Feeley Field

Town of Sudbury ADA Transition Plan

December 2020

Institute for Human Centered Design

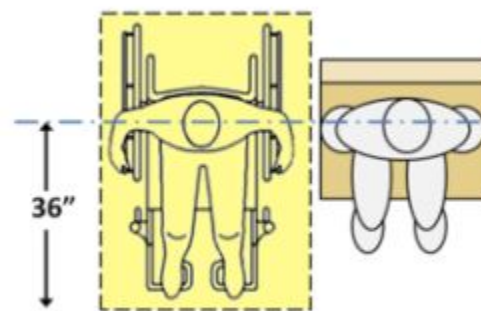
- Recommend providing handrails at the stepped route to spectator seating north of the baseball field.
- Recommend providing clear floor space of 36" wide minimum by 48" deep alongside one bench so that a wheelchair user can sit alongside someone sitting on the bench. See the following diagram:
